Town Diagram of Setback Lines, Arborist Recommendations and Engineering Design Standards, as shown on the Project's Development Plans

GRADING & DRAINAGE PLAN
LANDS OF ROPER
16 CHESTNUT AVENUE
LOS GATOS, CALIFORNIA

SHEET NUMBER
C4
OF 8 SHEETS
DRAWING NO.
18045-C4

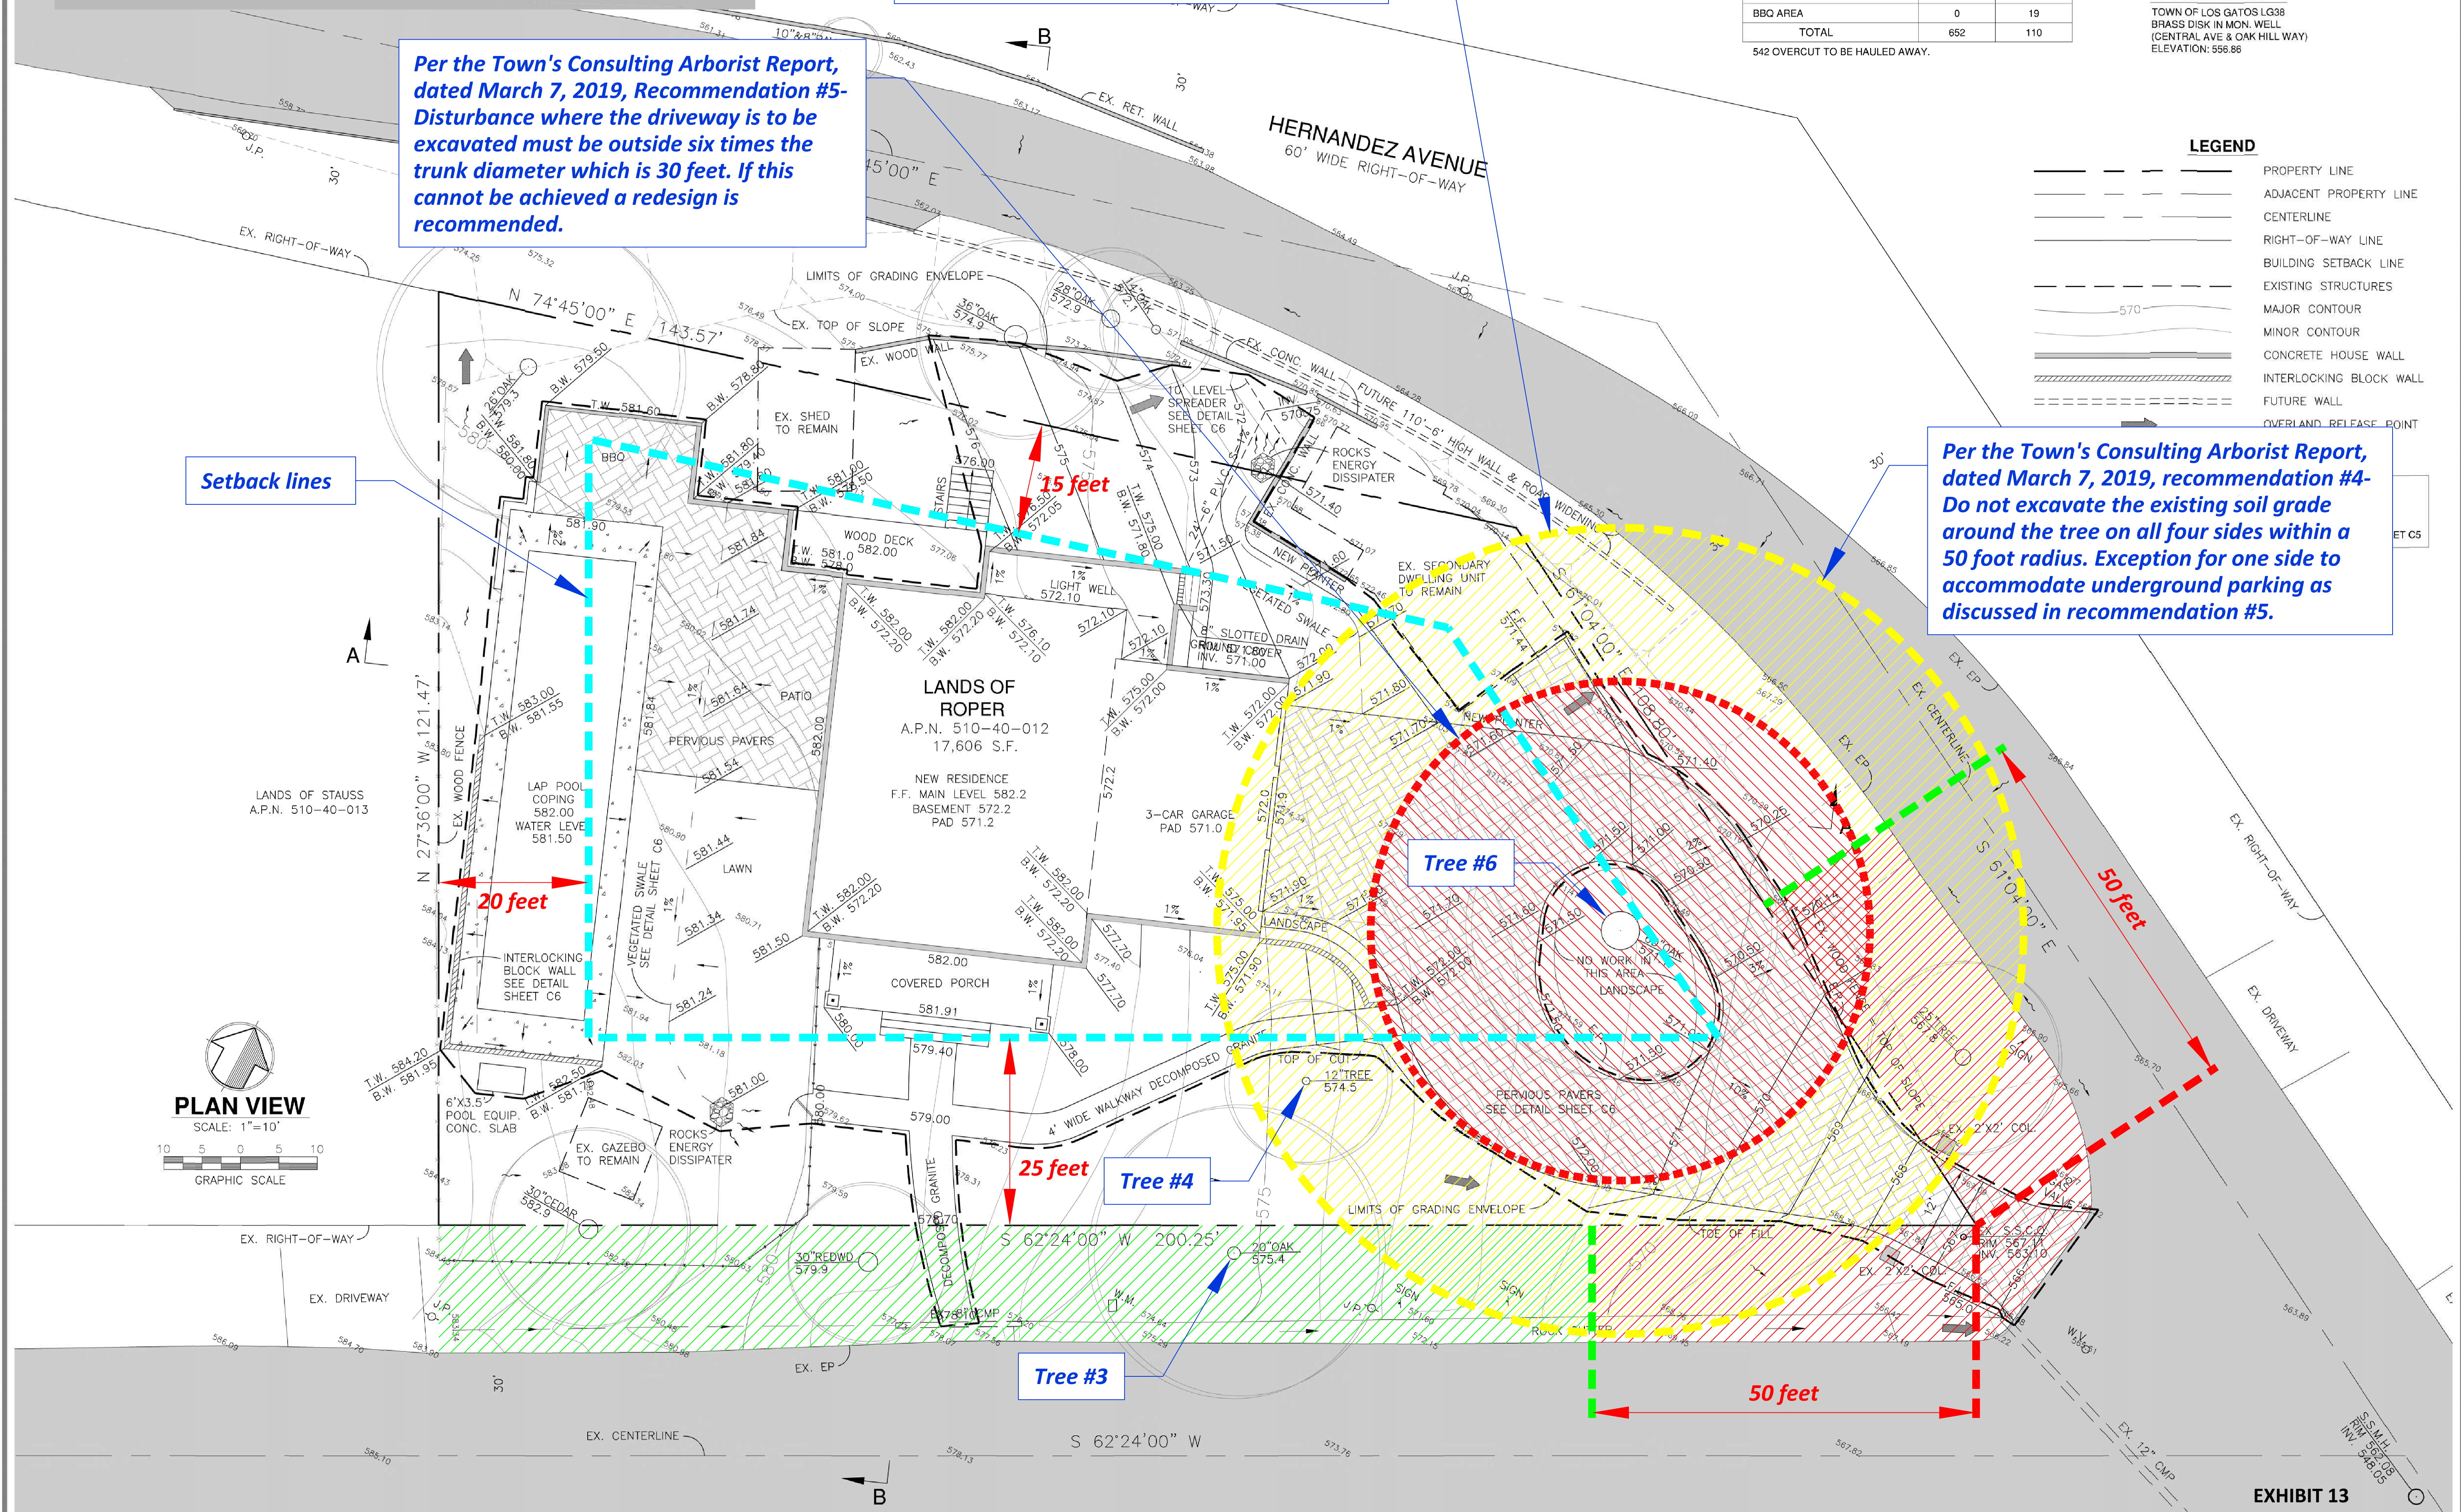
Recommendation #6- All paver installation within 50 feet should be above the existing soil surface with only minor scarification to even out the grade under the existing asphalt. - Create a new paver section to indicate the driveway will be placed above existing grade without sub-base excavation.

Per the Town's Consulting Arborist Report, dated March 7, 2019, Recommendation #5-Disturbance where the driveway is to be excavated must be outside six times the trunk diameter which is 30 feet. If this cannot be achieved a redesign is recommended.

Per the Town's Consulting Arborist Report, dated March 7, 2019, recommendation #4- Do not excavate the existing soil grade around the tree on all four sides within a 50 foot radius. Exception for one side to accommodate underground parking as discussed in recommendation #5.
